Addendum No. 1
Four Rivers Sanitation Authority
Maintenance Building Renovation
Capital Project No. 2102

This Addendum Number 1, dated July 17, 2026, for the above-referenced project, supersedes all contrary and conflicting information in the specifications and contract documents, which are hereby supplemented or revised as follows:

3 Wall Section - New Work @ Studs
Scale: 1" = 1'-0"

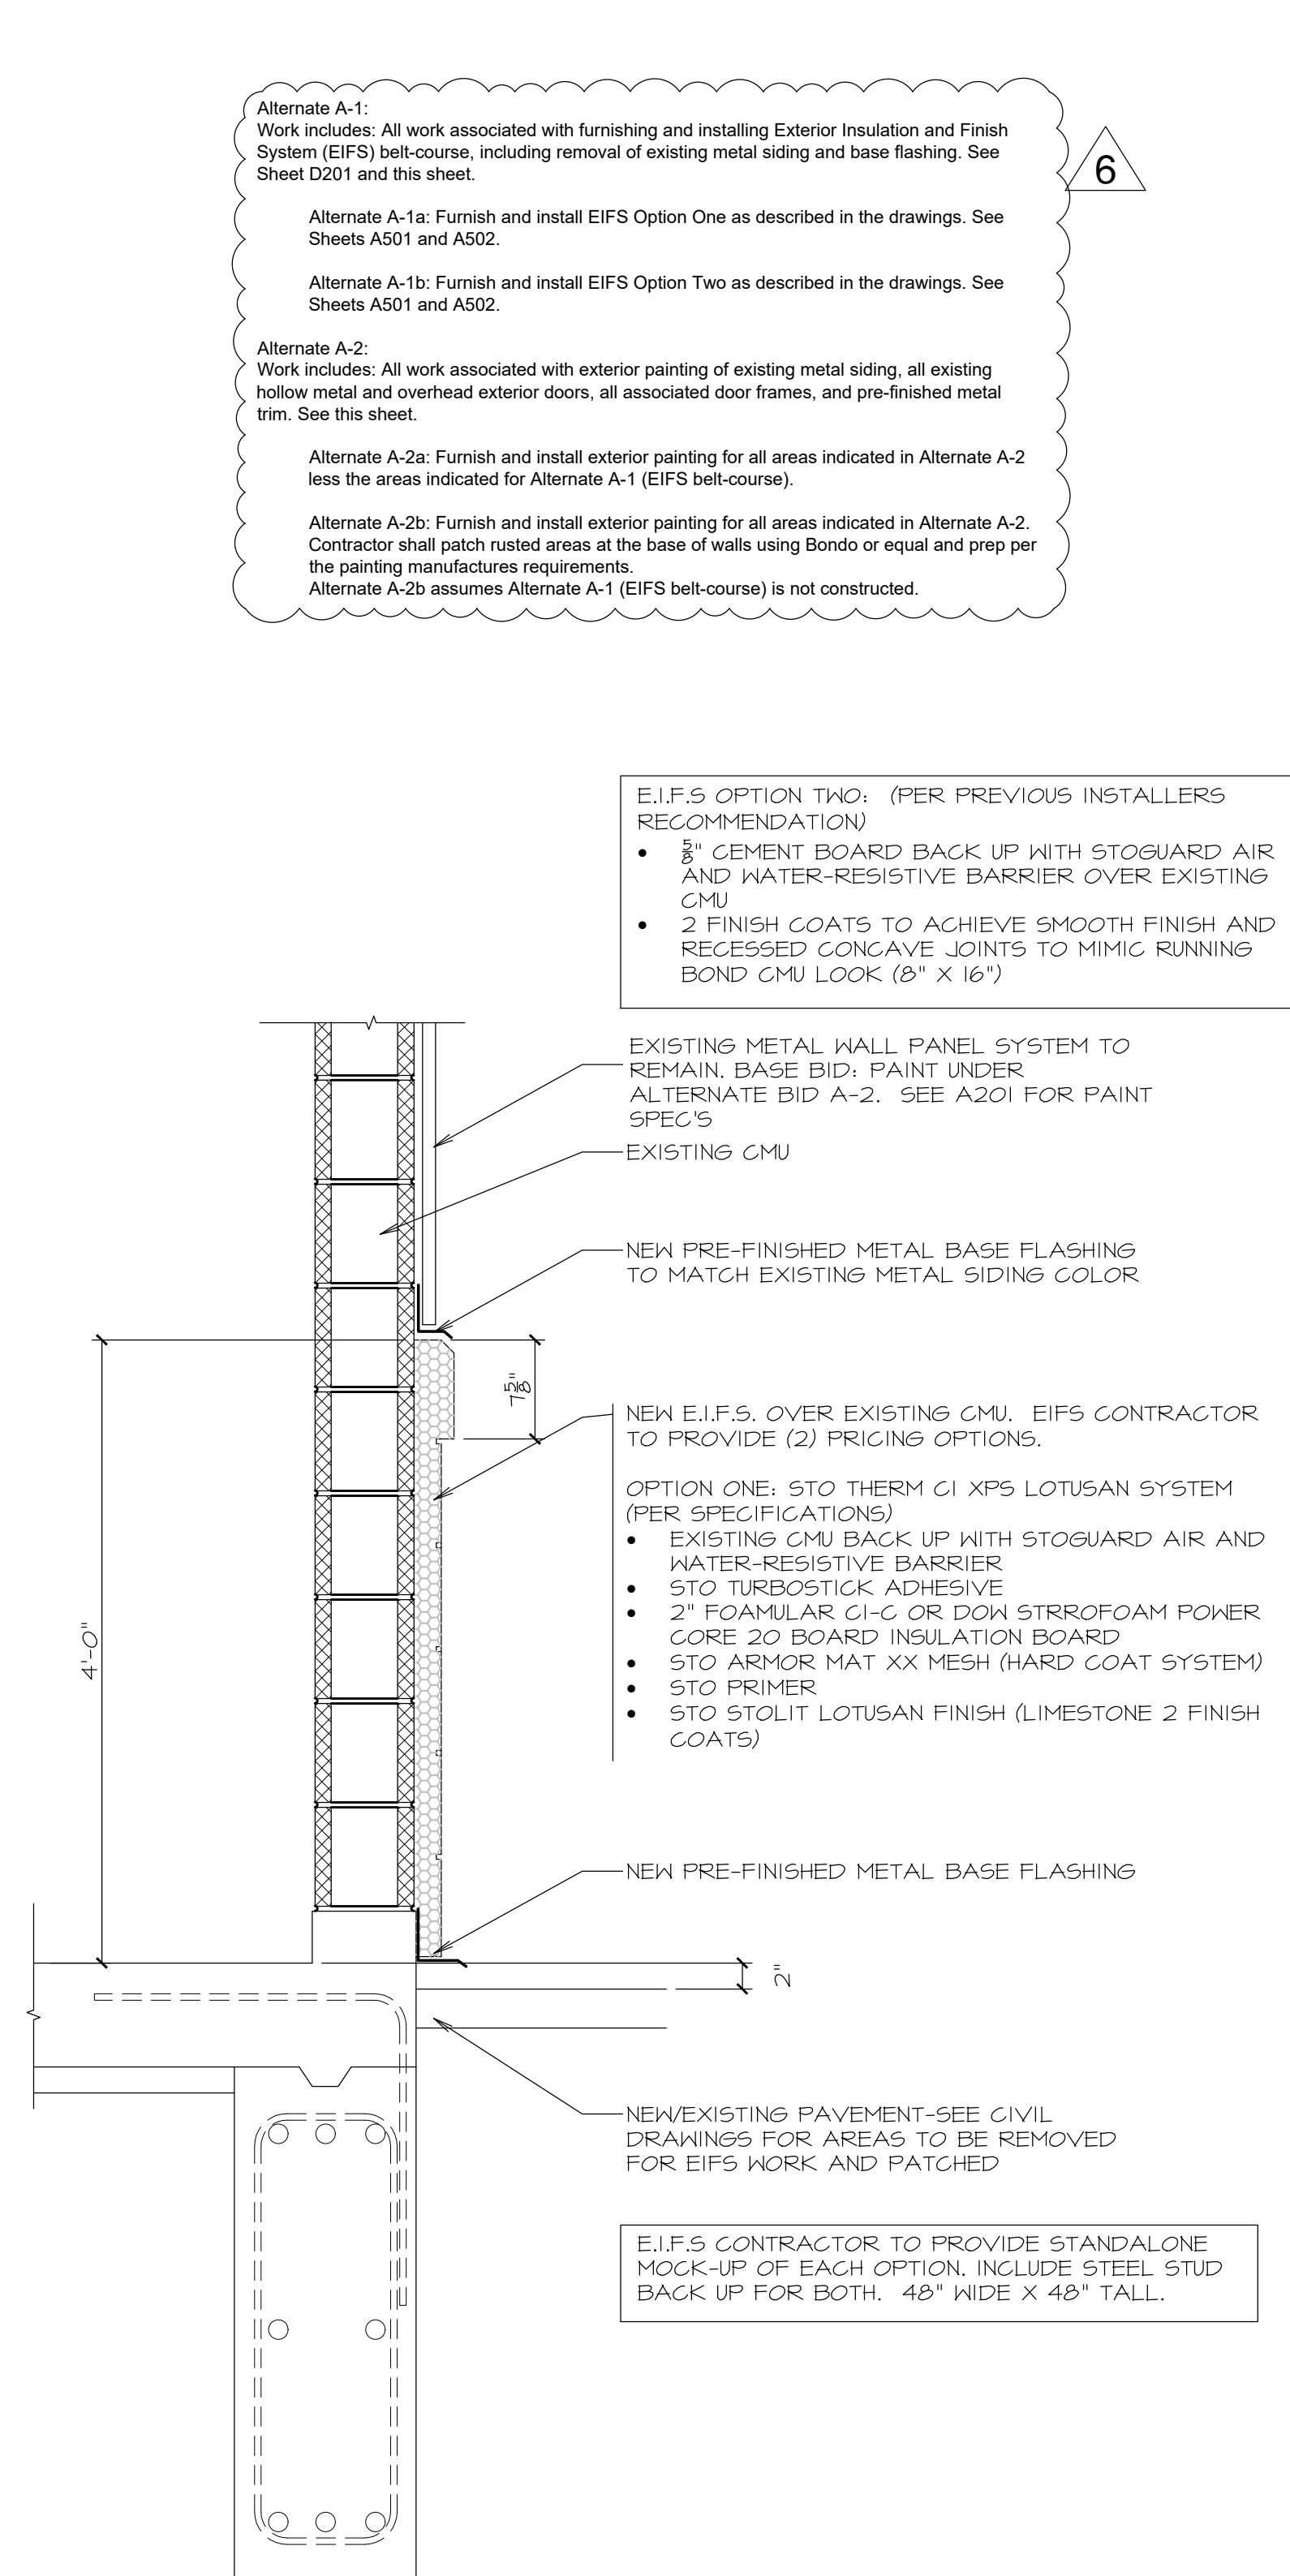
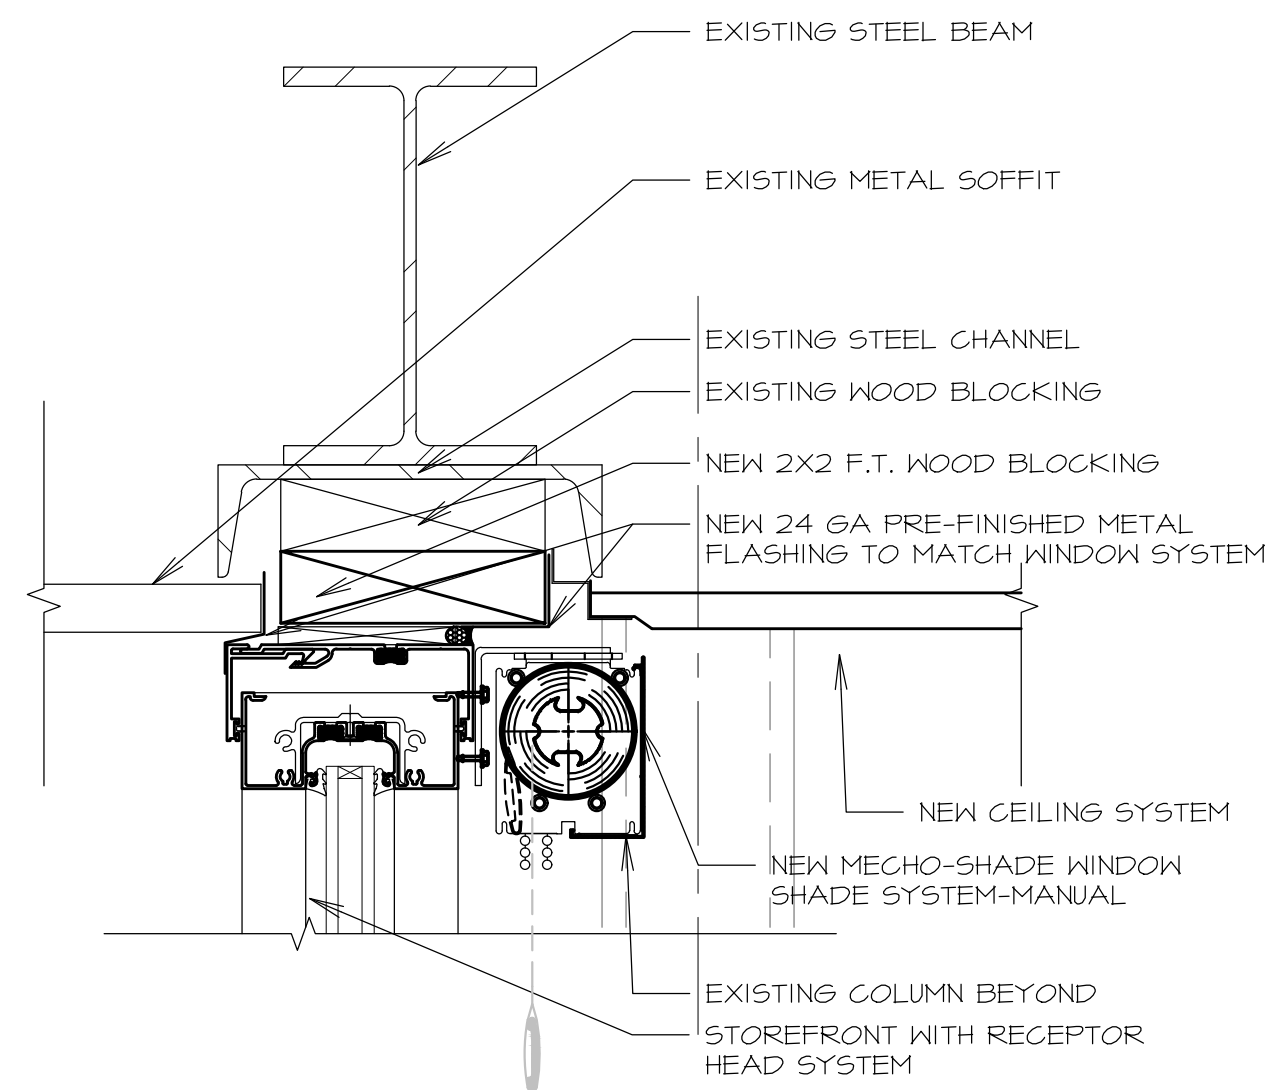
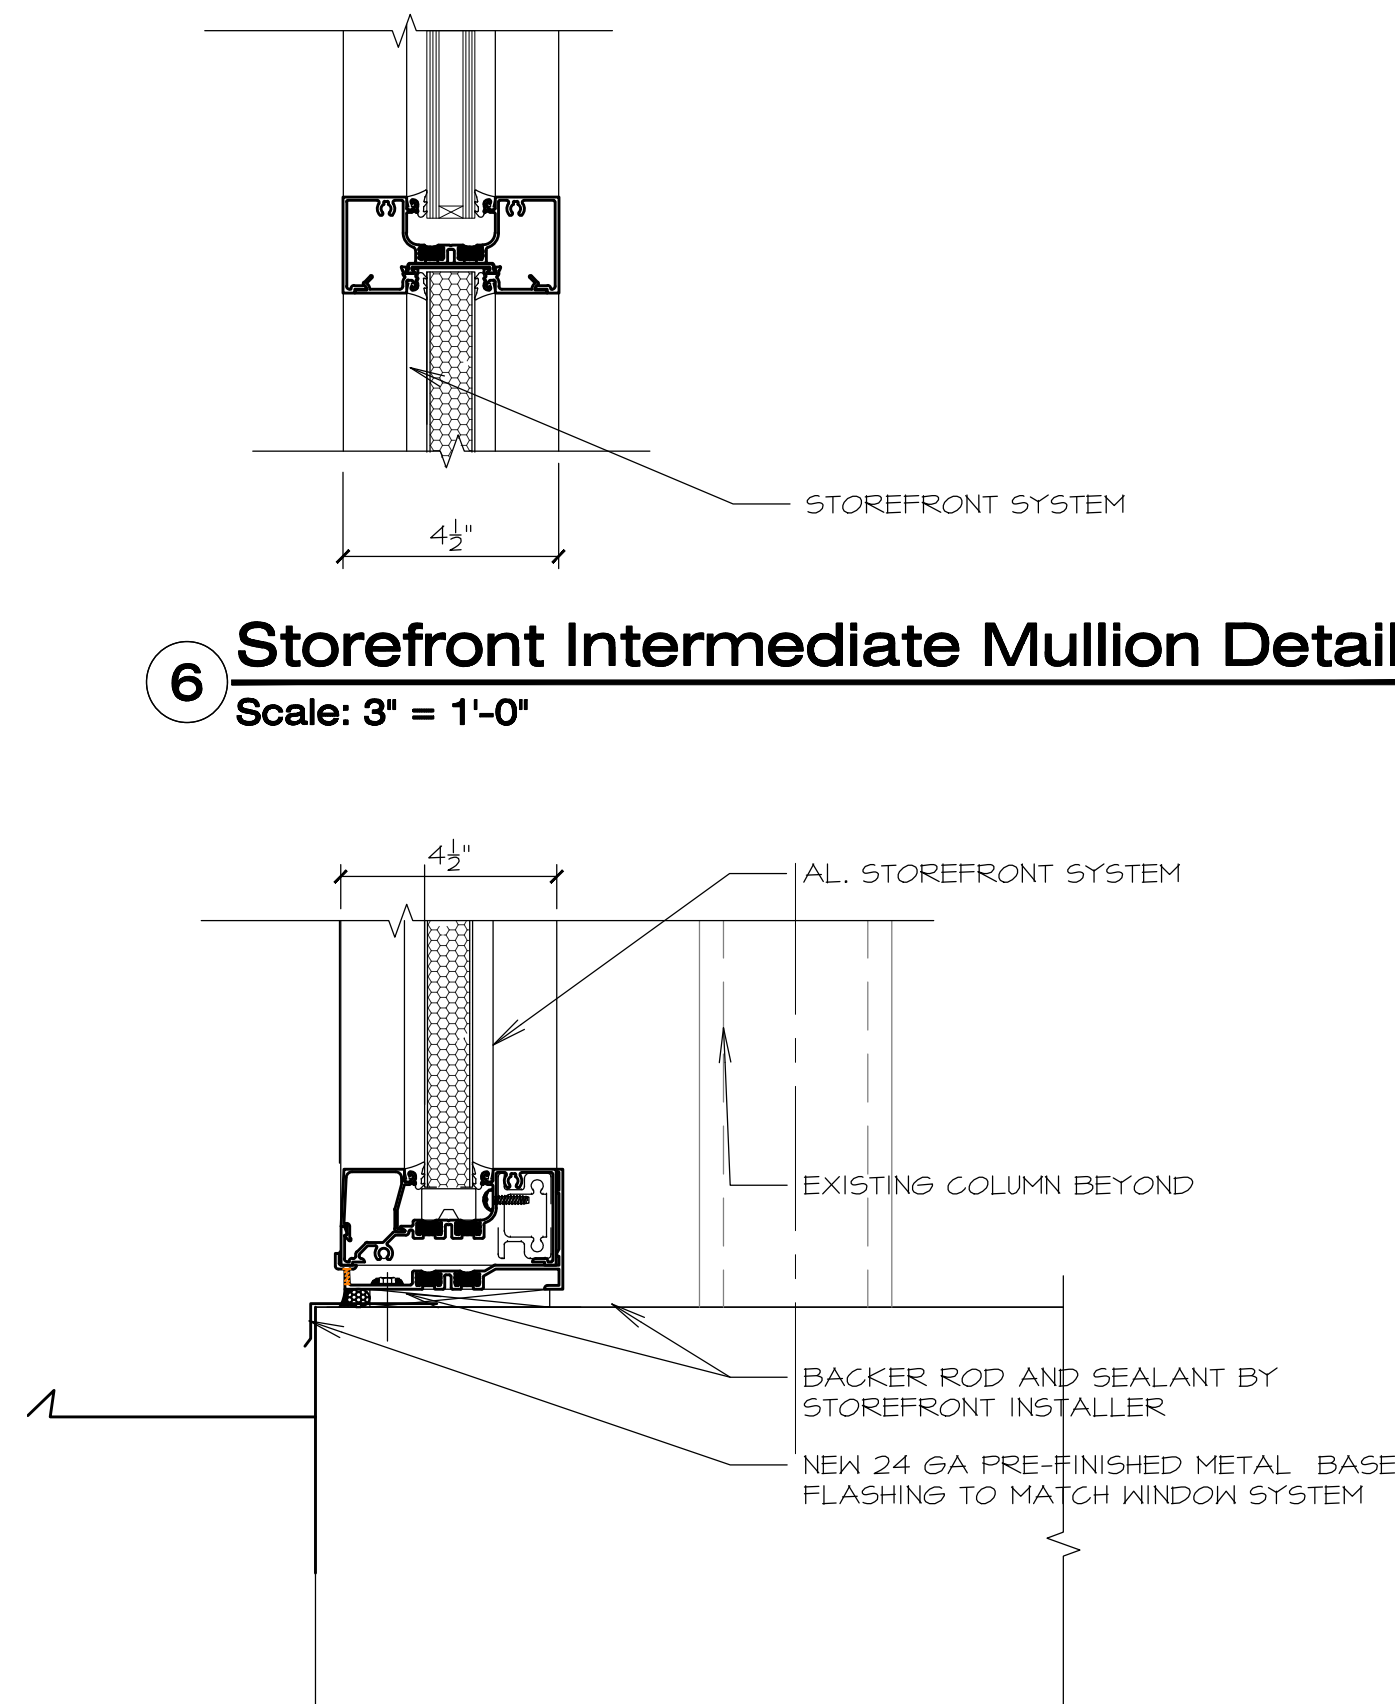
Plan Sheet A501 Details: DELETE Sheet A501 in its entirety and REPLACE with the attached revised sheet which clarifies Alternates and EIFS Options One and Two and corrects steel stud sizes.

Alternate A-1:
Work includes: All work associated with furnishing and installing Exterior Insulation and Finish System (EIFS) belt-course, including removal of existing metal siding and base flashing. See Sheet D201 and this sheet.

Alternate A-1a: Furnish and install EIFS Option One as described in the drawings. See Sheets A501 and A502.

Alternate A-1b: Furnish and install EIFS Option Two as described in the drawings. See Sheets A501 and A502.
